**Planning application no. ES/3379
by Island Gas Limited to drill at
Springs Road, Misson, Nottinghamshire:
Objection on grounds of geology and hydrogeology**

**By
David K. Smythe
Emeritus Professor of Geophysics, University of Glasgow**

December 2015

Figure 2. Part of the BGS regional cross-section from the 1: 250,000 Humber map, which passes through the Misson site (red line). The extract, which is about 40 km long, runs from Worksop in the SW to Scunthorpe in the NE.

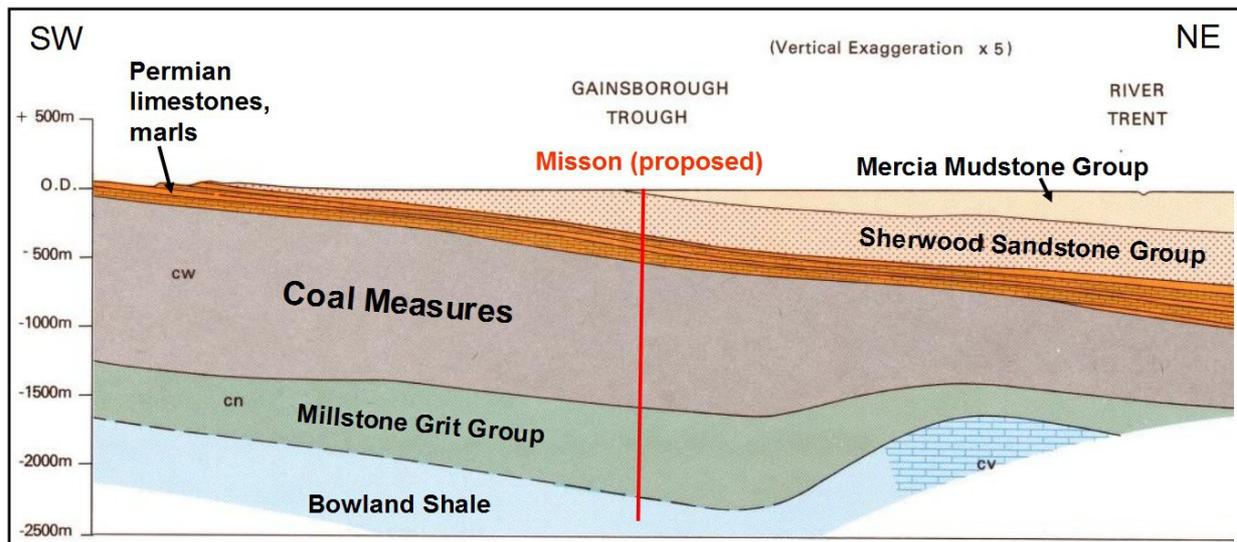
The Sherwood Sandstone Group (SSG) is a Principal Aquifer. Figure 2 shows that the Applicant proposes to drill through a few metres of Mercia Mudstone Group (MMG),

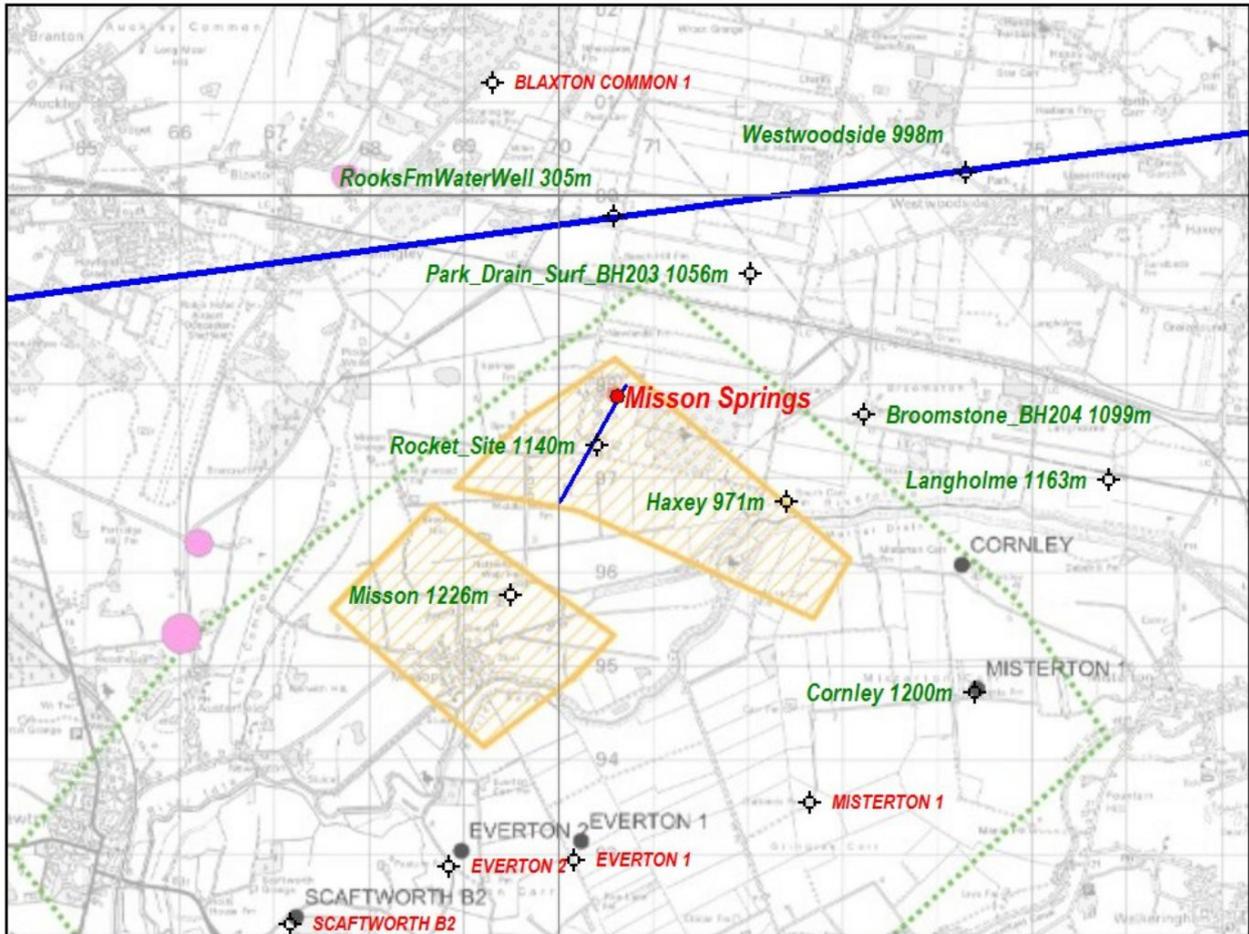
Appendix F Groundwater, section 4.6, of the application discusses the bedrock geology, with reference to borehole SK79NW/30. This is the Rocket Site borehole shown in Figure 5, situated 540 m SW of the vertical wells and above the proposed horizontal well (the latter is shown in blue). But this borehole is not shown on the relevant Application Drawing no. 22, which forms the backdrop to Figure 5. Only five boreholes are marked on this drawing, shown by the black dots labelled with the well name in upper case.

The 3D seismic survey is, in principle, a necessary and welcome background dataset to the application (Vol. 3 Environmental Statement, section 5.5), but no further information is supplied, other than an outline of the surface survey coverage (shown by the green dotted outline in Figure 5), and the fact that the survey covered some 7000 Ha (it is actually 68 km²).

This sentence is essentially meaningless without the provision of extra information. The Applicant should have supplied the information required to justify the statement. Figure 5 shows that neither the Misson nor the Haxey well were used by the Applicant, even though they both lie within or at the edge of these two selected areas. In addition, the Rocket Site borehole does not have the necessary electric logs for tying in well depths to the 3D seismic. Note again from Figure 5 the gross mispositioning by the Applicant of the Misterton-1 and Cornley wells. Therefore the well-to-seismic ties essential for the Applicant's geological interpretation could be grossly in error, and will therefore nullify any (unpublished) conclusions that the Applicant may have come to regarding geological structure and reservoir properties. This in turn means that **the site selection process is demonstrably inaccurate.**

The choice of the two areas of search within the overall PEDL search area, that is, the two yellow hatched polygons in Drawing 22 (reproduced with overlays in Figure 5), is not justified by the imprecise definition under the Applicant's heading Areas of Search:

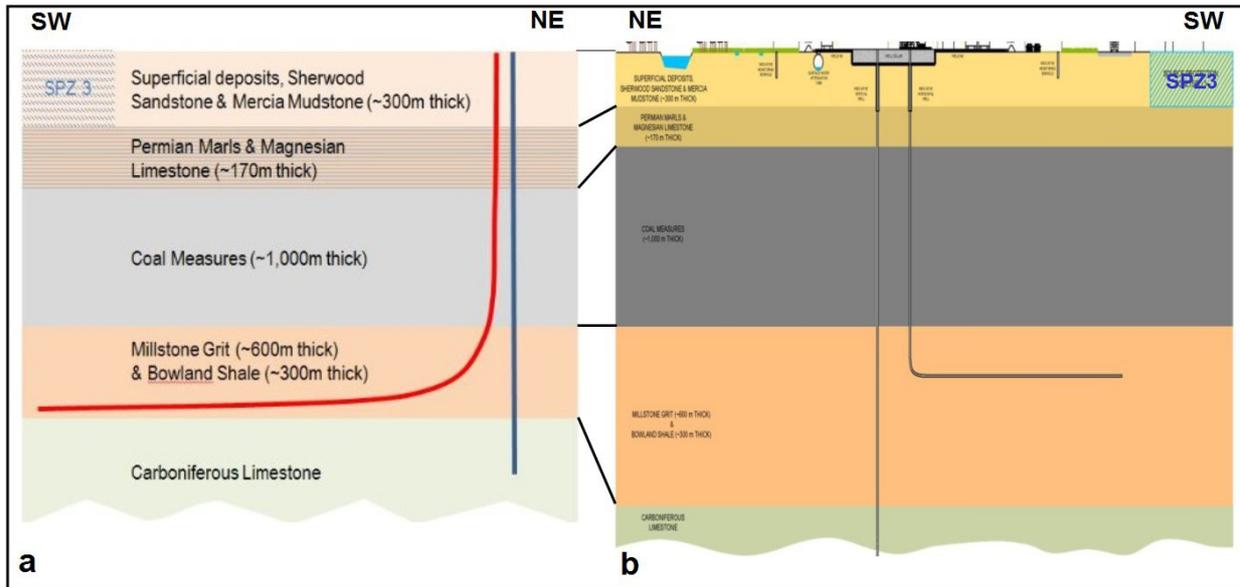
The Applicant concedes that Sherwood Sandstone Group is at solid outcrop below superficial deposits at the Rocket Site borehole, but qualifies this admission: "*... it is possible that part of the recorded 'Drift' (superficial deposits) represents weathered Mercia Mudstone.*" (Appendix F section 4.6). Evidence for the solid rock outcrop around the site is discussed below. The nearest that the Applicant comes to portraying a geological cross-section through the proposed wells comprises two cartoons, reproduced herein as Figure 6, purporting to show the strata to be encountered. The errors in thicknesses depicted in these cartoons are discussed below.

The figures quoted by the Applicant in both cartoon cross-sections (Figure 6) contain gross errors. Firstly, we compare the cartoons with an annotated version of the BGS cross-section traversing the Doncaster 1:50,000 geological map. This cross-section passes the proposed development 1.8 km to the north. The annotated cross-section is shown in Figure 12. It has been vertically exaggerated by a further five times, on top of the original's x2 exaggeration, so it is now x10 vertically exaggerated. The hydrogeological implications of this cross-section are discussed below.

Secondly, I have redrawn the Applicant's cartoons (Figure 6) as a properly scaled cross-section along the line of the proposed horizontal borehole. This is shown in Figure 13. The Rocket Site borehole is projected onto the section from 55 m to the SE. The position of the Misson fault is uncertain by about ± 150 m either way along the section from its marked place, but it has to lie to the NE of the Rocket Site borehole. I have put an arbitrary slight hade (inclination from the vertical) on the downthrown side, and retained a constant estimated 30 m throw for the whole depth. The actual dip and the throw may be somewhat different.

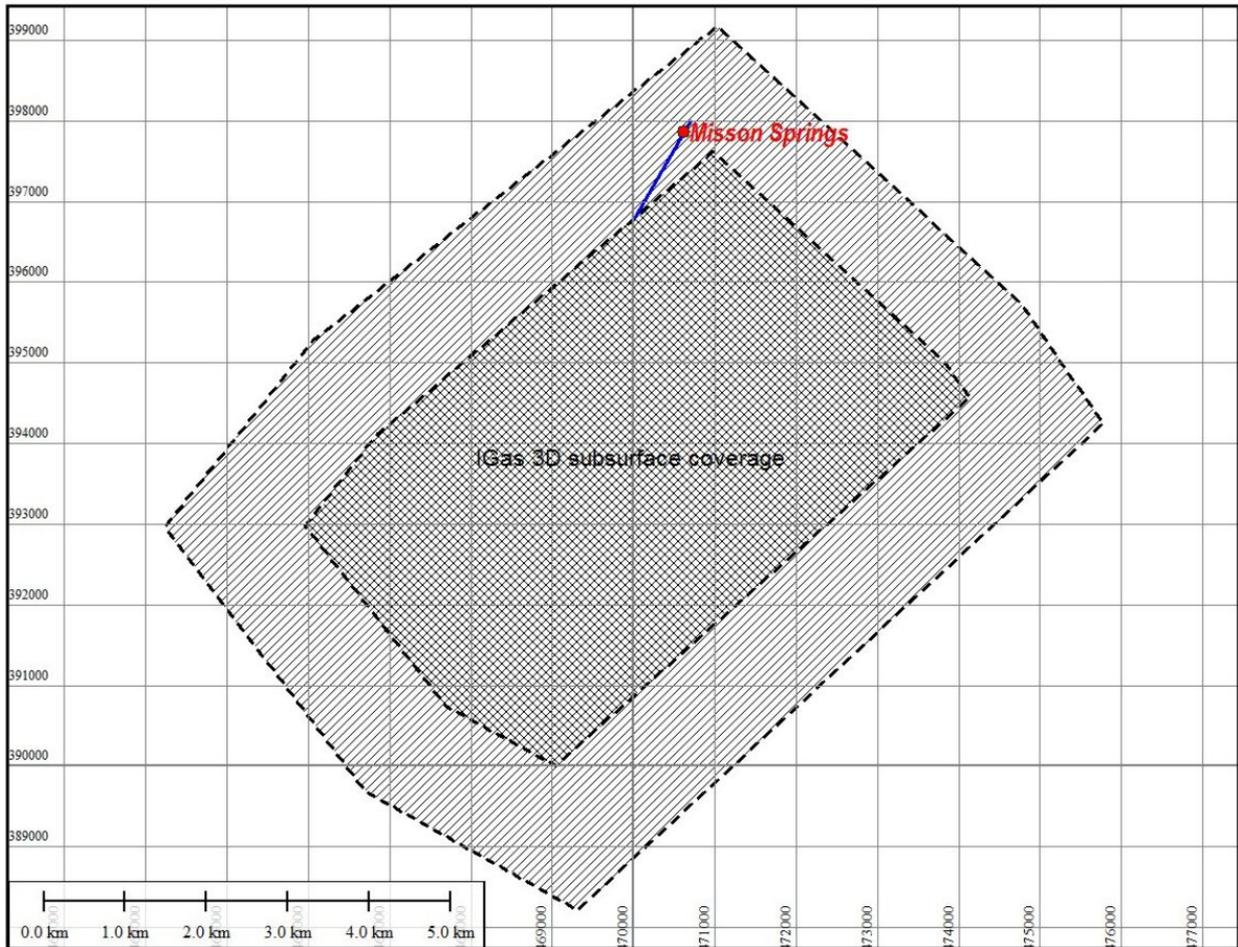
But only within the area of *subsurface coverage* is the survey at its 'full fold', and therefore capable (in principle) of imaging all the structure below. Fold, or multiplicity of coverage, is the principal measure of the data quality. The surface coverage area and the inner subsurface coverage are both shown in Figure 7. I have estimated the latter from the former by assuming that the maximum source-receiver offset is 3 km, resulting in the fringe, or apron, zone of 1.5 km around the subsurface coverage area. Outside of this inner area, the data quality diminishes progressively from full-fold at the edge of the inner zone to 1-fold at the edge. So the 3D image below the proposed drillsite will be of poor quality, because both the vertical and horizontal wells lie within the fringe zone.

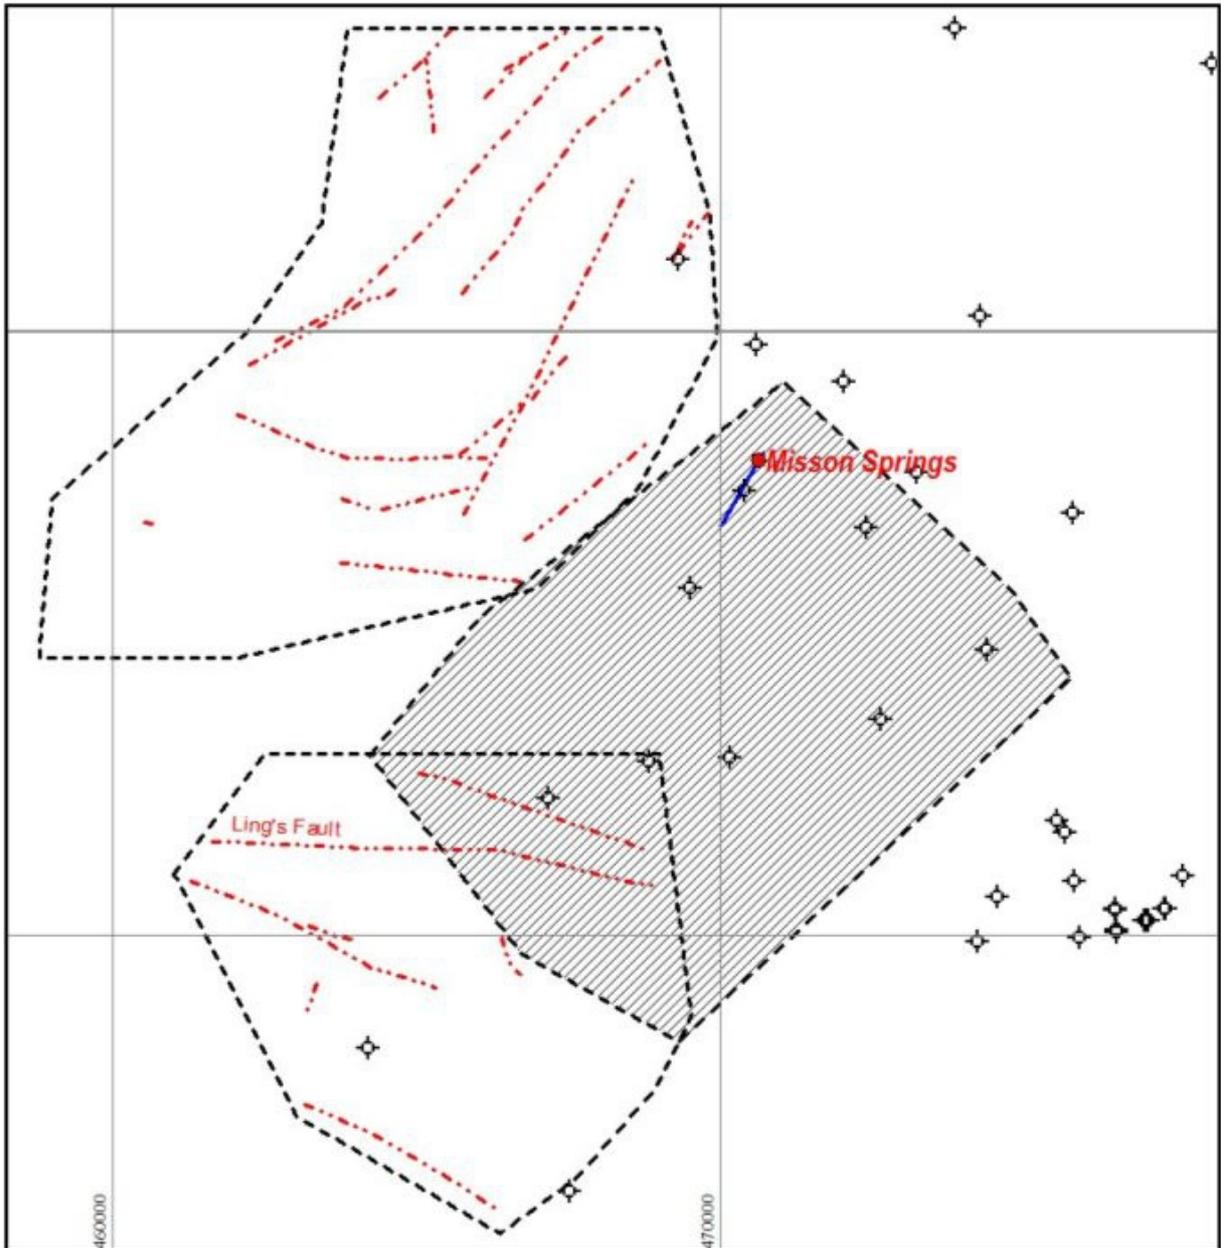
There are two former collieries in the vicinity of the proposed development, Rossington to the west and Harworth to the SW. A review for the Department of Trade and Industry (IMC Group Consulting Limited 2004) includes detailed maps on the coal seams, including faulting, at these two collieries. Figure 8 shows the areas outlined by a black dashed line within which faults have been mapped (red dash-double-dotted lines). The depth of the seams proving the faults is of the order of 1000 m.

These two areas show that faulting is significant, and that faulting in the Coal Measures can be identified using seismic reflection data. It is therefore inexplicable that the Ling's Fault, together with the sub-parallel fault to the north, was not identified on the

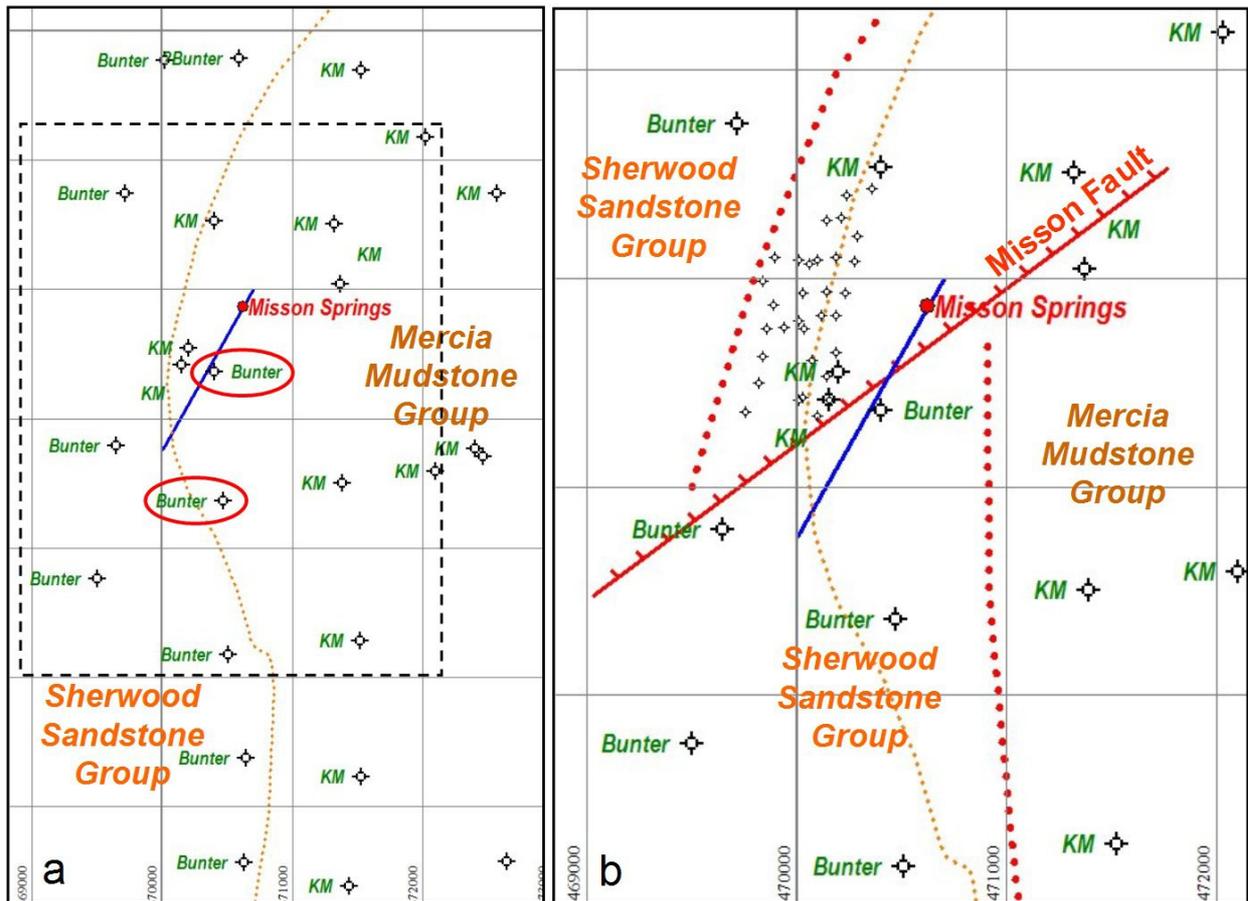
The feather-edge of the Mercia Mudstone Group (MMG) in the vicinity of the proposed development, as marked on the BGS Doncaster 1:50,000 map, mismatches the evidence from boreholes which were drilled after the map was published in 1969. But the Applicant persists in using the out-of-date information in this regard. Figure 11a shows the feather-edge of the MMG from the 1969 map (yellow dotted line) in relation to the site and surrounding boreholes. Solid rock encountered in the boreholes is indicated by the old names; Keuper Marl (KM) is now the MMG, and Bunter (Sandstone) is the Sherwood Sandstone Group (SSG). But the feather-edge is discrepant at two localities, circled in red in Figure 11a, where SSG was drilled at solid rock outcrop, and not MMG, as would be expected from the mapped boundary.

A more detailed area around the site is shown in Figure 11b, which covers the area shown in Figure 11a outlined by the dashed black rectangle. Thirty-one Misson Springs shallow boreholes are shown in this detailed map by small well symbols; all these boreholes indicate that bedrock was either not reached, or that it may have been weathered MMG. So the feather-edge of the MMG has to be revised to honour the data, and this is shown by the heavy red dotted lines in Figure 11b. The only feasible way to account for the offset is by postulating a fault, which I call the Misson Fault, trending NE-SW through the proposed development. It is constrained to lie north of the Rocket Site borehole, which lies on the trajectory of the proposed horizontal well. Geometrically, the data could be also fitted by a sinistral wrench fault, but since this style of faulting does not occur in this region, such an alternative explanation is unlikely.

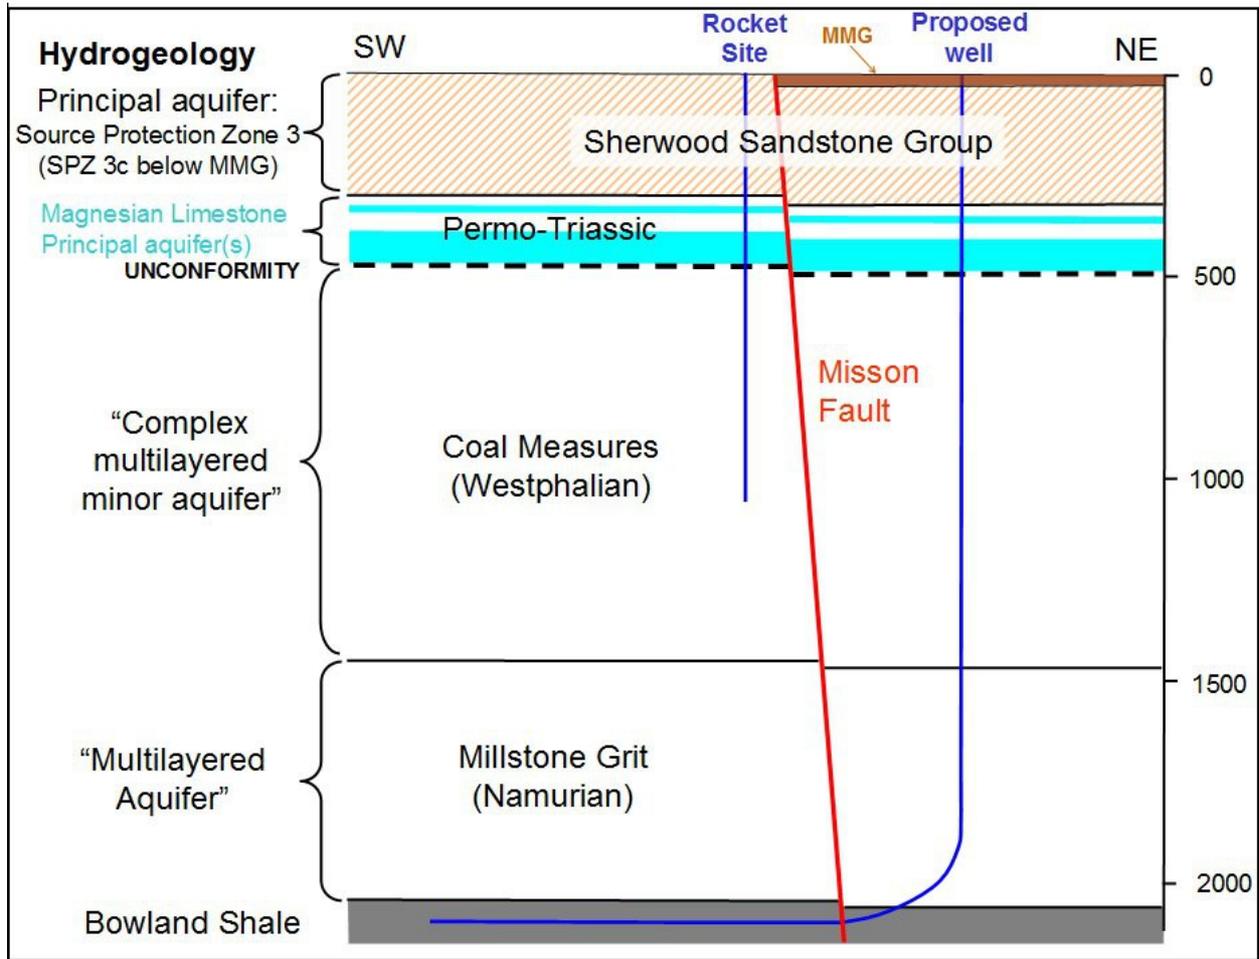
Formation tops from Everton-1, some 5 km along strike to the south, and Scaftworth-B2, 6.6 km to the SW, are used to estimate the thicknesses of the Lower Coal Measures and the Millstone Grit. According to the BGS (Andrews 2013) the Bowland-Hodder Unit reaches more than 2 km in thickness (Fig. 4), of which only 234 m was penetrated at Scaftworth-B2. The Applicant's cartoons (Figure 6) lump together the Millstone Grit and the Bowland Shale into one geological unit, the thickness of the Bowland Shale being stated as about 300 m. Even if this last figure is supposed to represent net shale in the upper Bowland Unit only, the actual figure for this is 474 m at Scaftworth-B2 (Andrews 2013). Such errors are unacceptable.

As seen in Figure 13, these two aquifers lie between 338 m and 475 m depth, and will therefore contain fresh water. Since these aquifers (or effectively one aquifer, following the BGS view stated above) lie shallower than 500 m below the development site, they (or it) have to be considered as potentially at risk as well as the SSG aquifer.
